**TOWN OF NEWBURGH  
PLANNING BOARD  
TECHNICAL REVIEW COMMENTS**

**PROJECT: LANDS OF MANN (FORMERLY MARTIN)**  
**PROJECT NO.: 15-09**  
**PROJECT LOCATION: SECTION 2, BLOCK 2, LOT 22.1**  
**REVIEW DATE: 15 JULY 2016**  
**MEETING DATE: 21 JULY 2016**  
**PROJECT REPRESENTATIVE: HERITAGE LAND SURVEYING**

SDS LAYOUT  
LOT 1

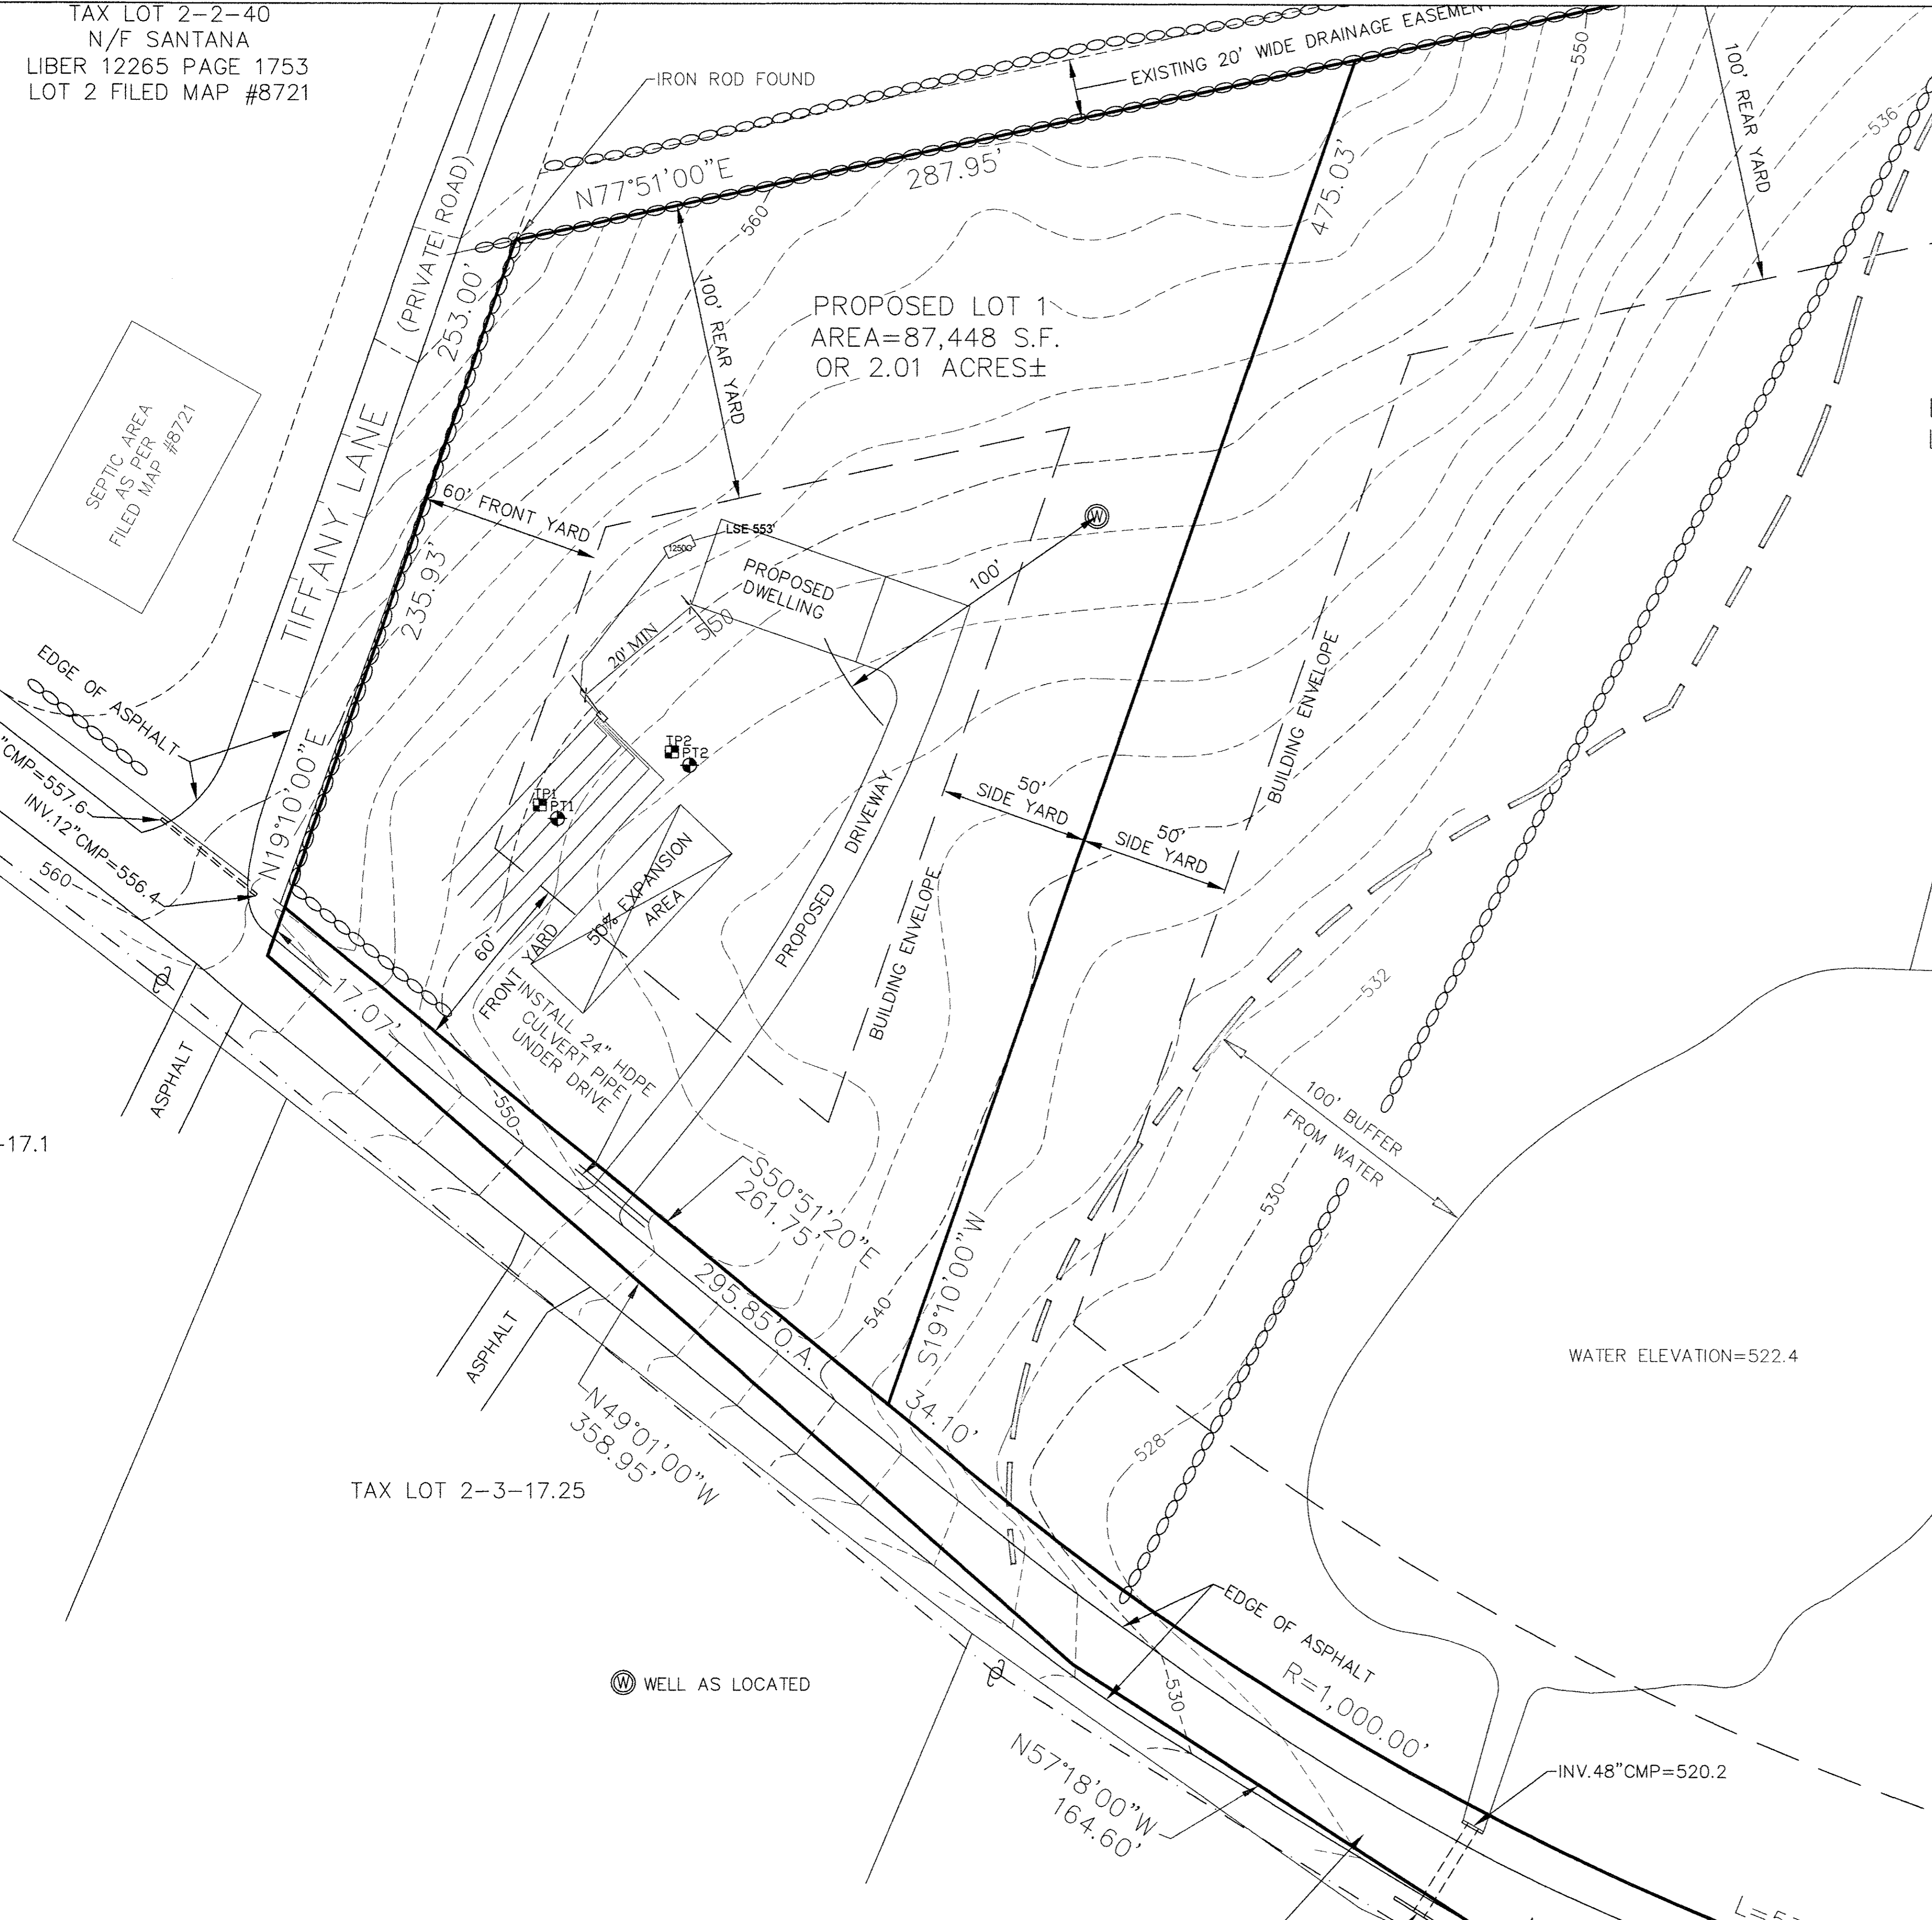
3. Note 16 on the sheet 3 of 5 should be revised to require the submission of an as built plan and certification to the Code Enforcement Office prior to issuance of a Certificate of Occupancy.

**SEPTIC TANK DETAIL**  
(SCHEMATIC), FOR GENERAL REFERENCE ONLY  
SCALE: None

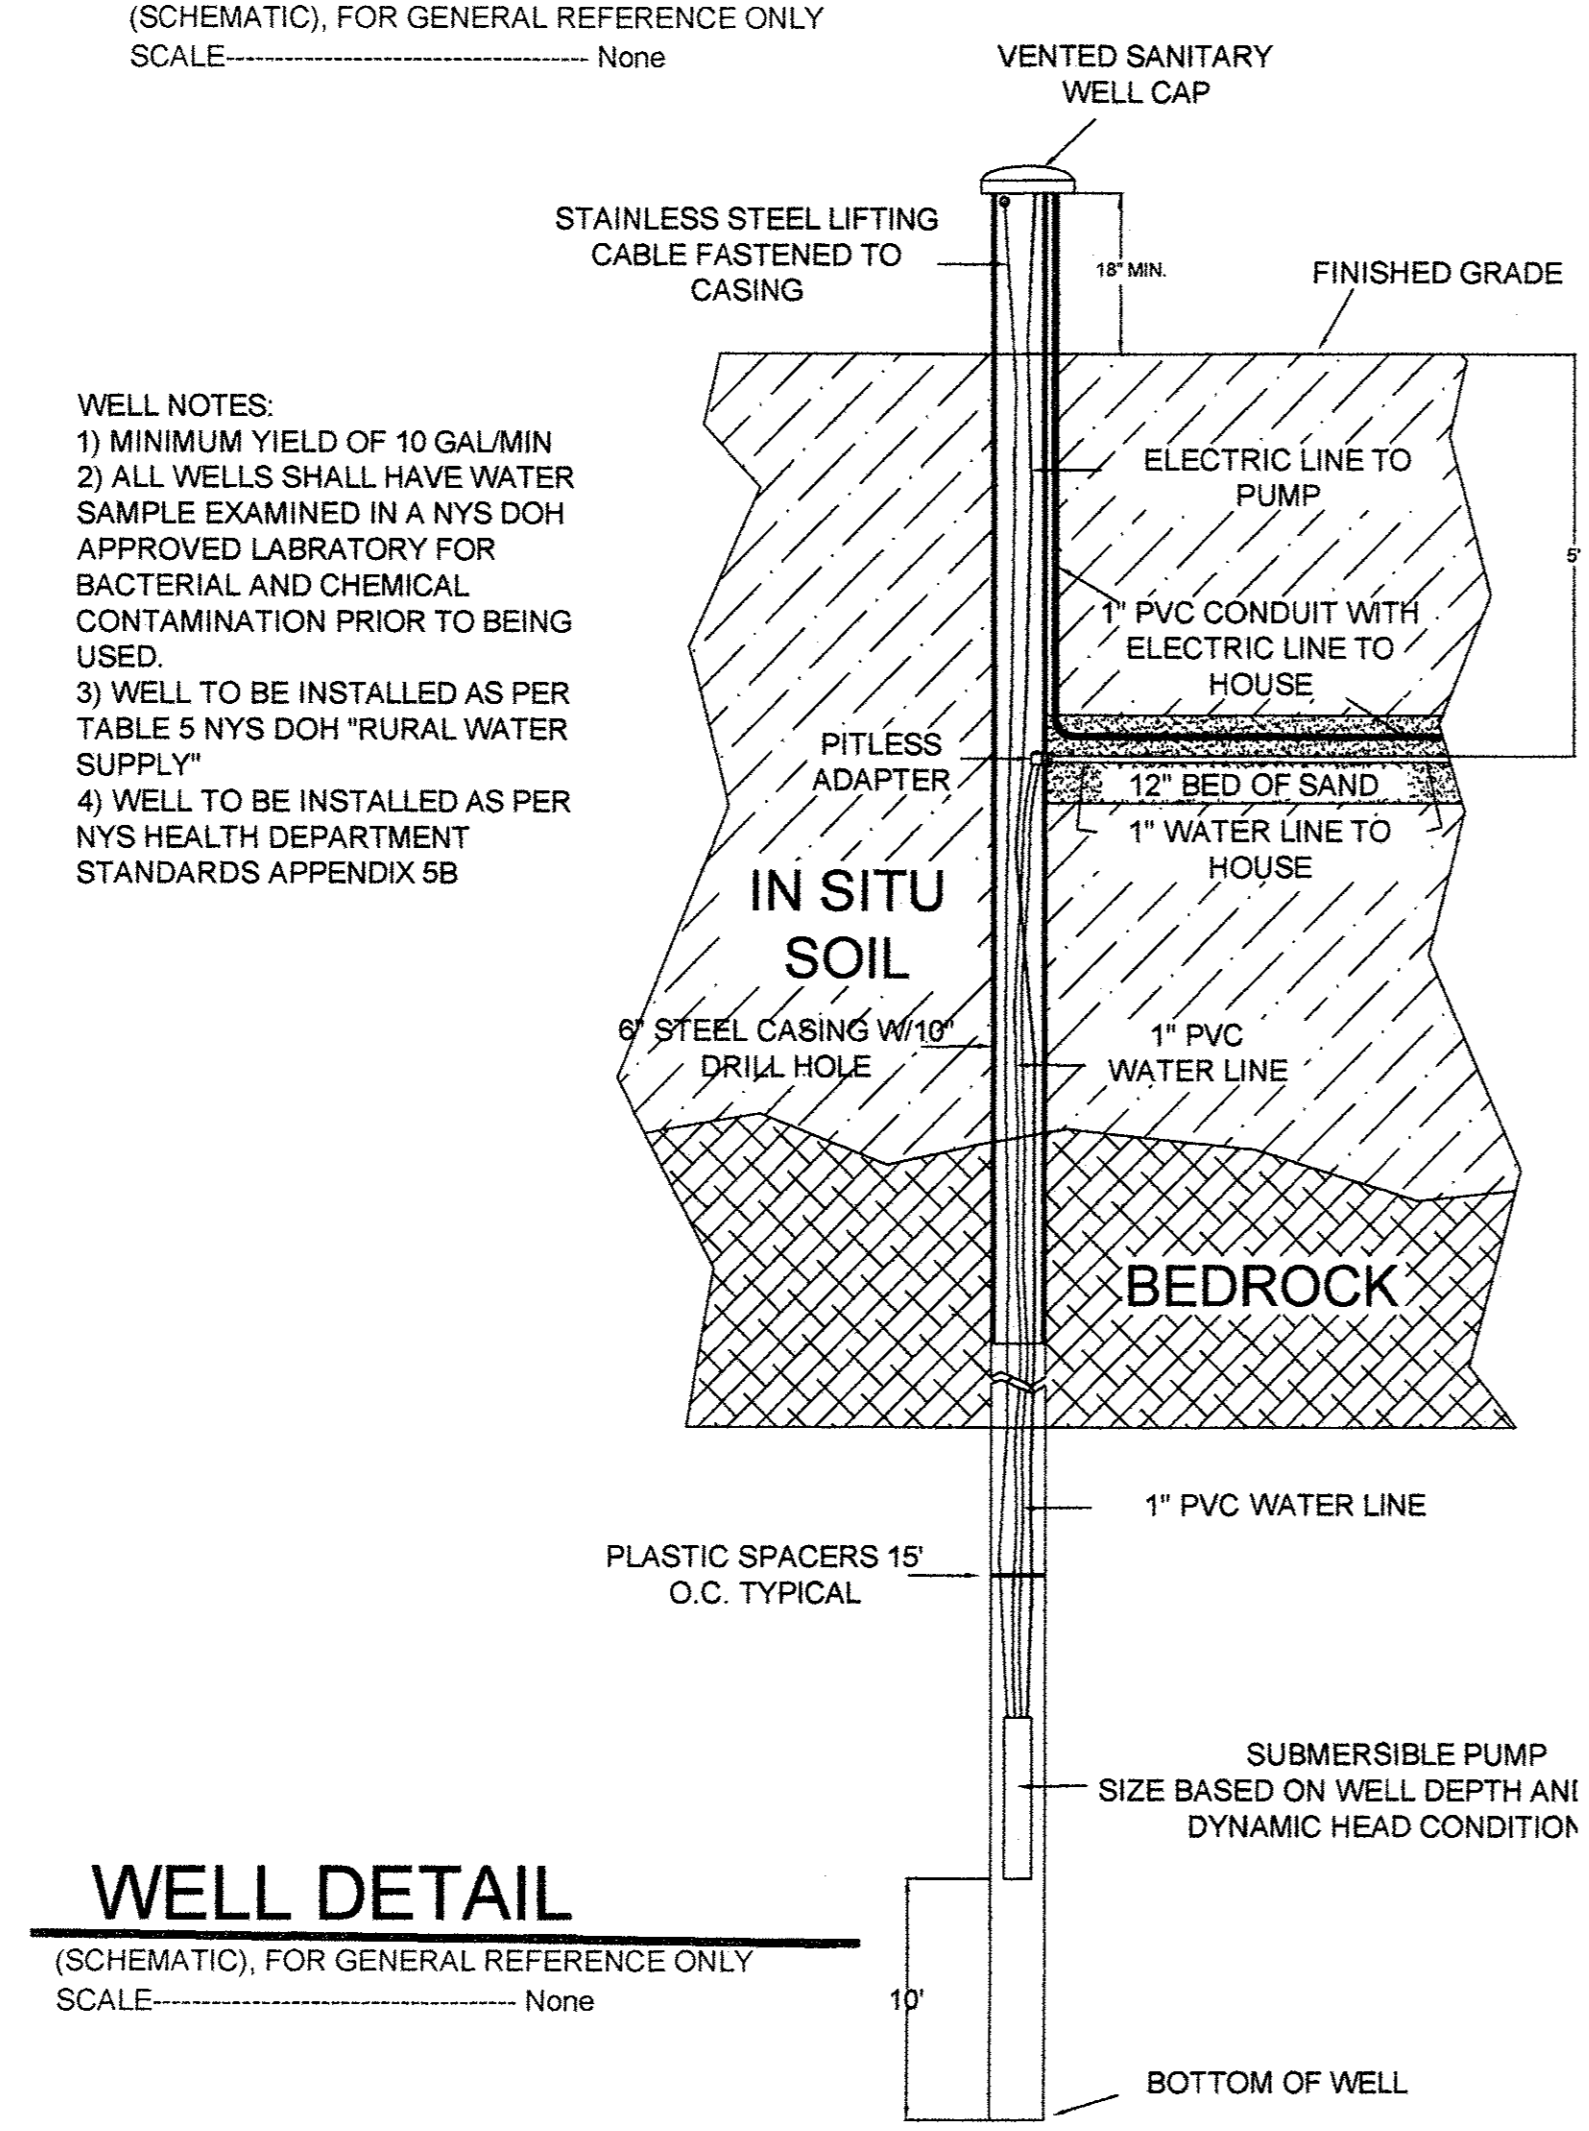
4. Plans have been revised for a 4 bedroom septic system. Septic tank detail should identify the size of the septic tank proposed, a minimum 1,250 gallon tank is required for 4 bedrooms.

**DRIVEWAY CULVERT**

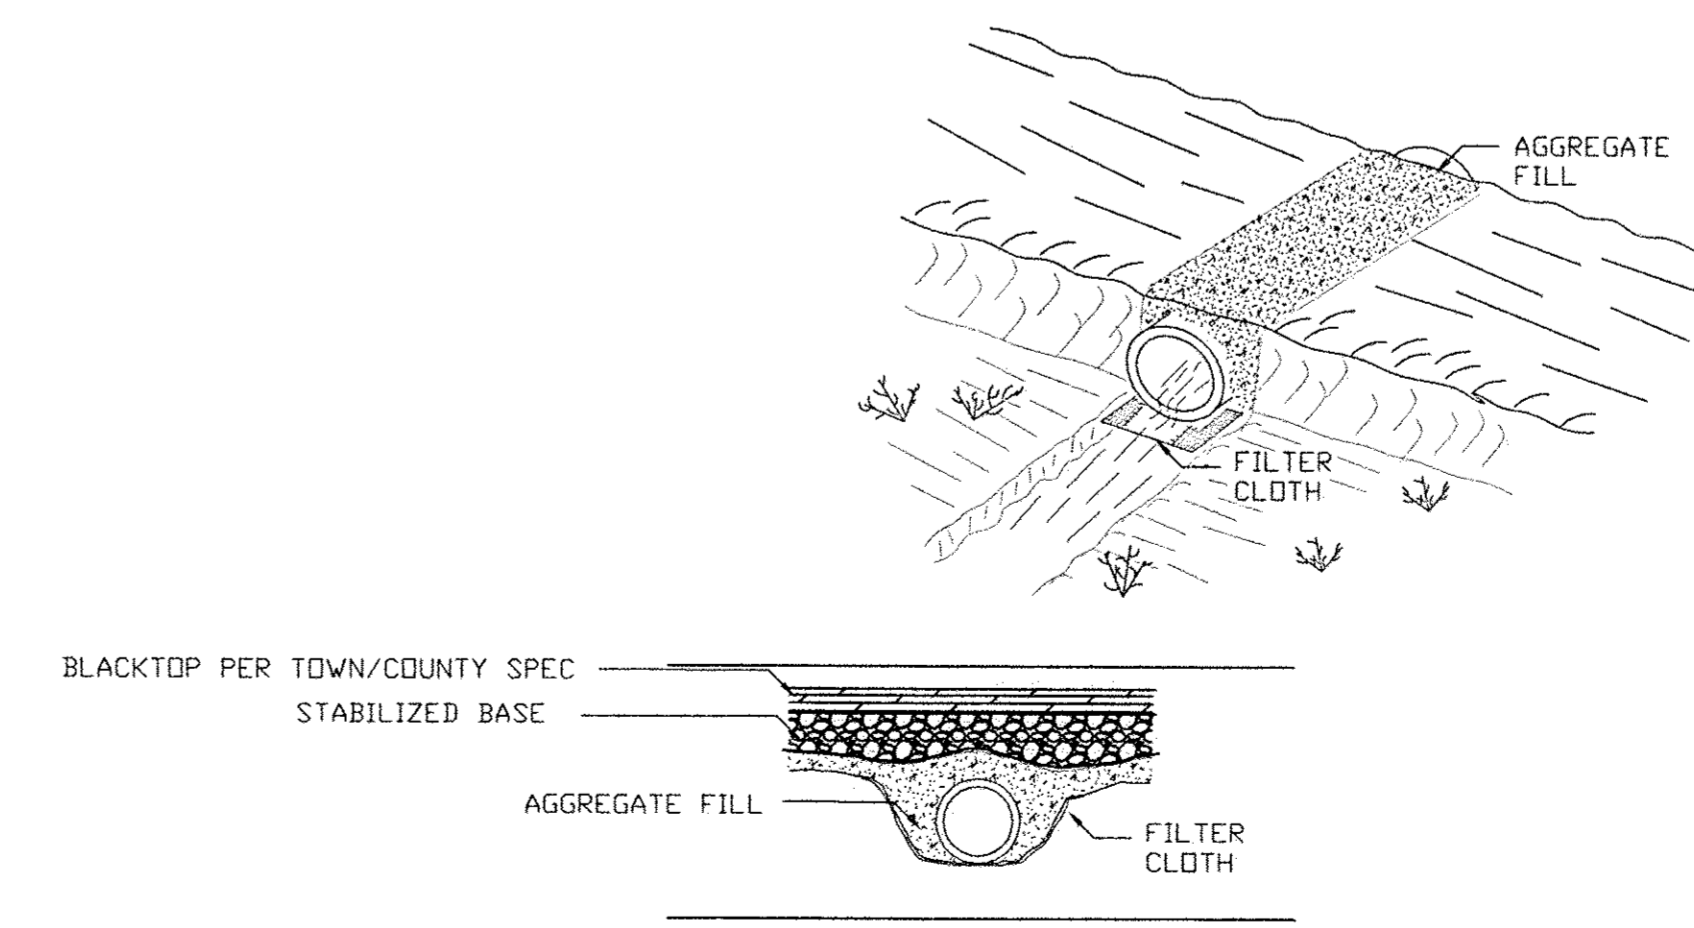
5. Highway Superintendent sign off for the driveway location and culvert should be received.
6. A Public Hearing is required for the subdivision. This office takes no exception to the Planning Board issuing a Negative Declaration for the 2 lot subdivision.
